SN6

Blues Brothers Pinball by Homepin

Service note six - (five pages)

Replace 5 x MOSFETS

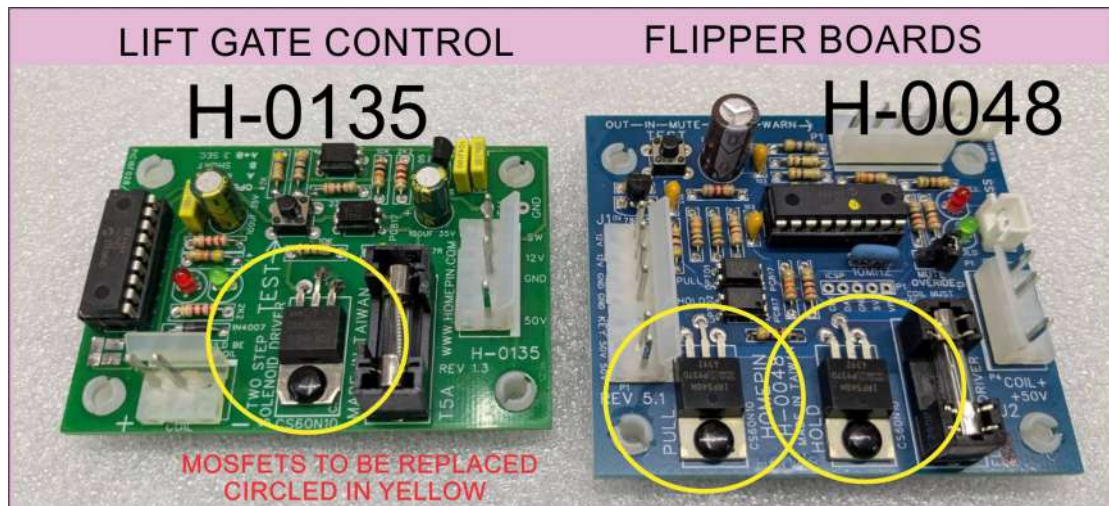
It has been reported that one of the flipper drive MOSFETS can randomly short causing the flipper to remain in the up position whenever power to the machine is switched ON.

Locate the three boards screwed under the playfield shown in the picture below. They are 2 x H-0048 flipper control and H-0135 lift gate control. Unplug the cables connecting to these boards and remove them from the playfield. Each board is held to the playfield with 4 x gold screws.

Replace the MOSFETS in the flipper control boards with a different type & also replace the lift gate control driver MOSFET. (detailed explanation at the end of this service note for those interested in more details).

Suitable replacements are IRF540N (note the “F” in the part number – NOT an IR-L-540N). Please don't buy these from dodgy online vendors such as Amazon, Ali-Baba, eBay etc as they are very likely to be fakes and you will only create more problems than you fix by using these parts.

Fit the replacement MOSFETS and fix them in place with the plastic clip before soldering and trimming the legs.

Check the fuses installed. The flipper boards should have a T3A (3 amp slow blow) and the lift gate board is a T5A.
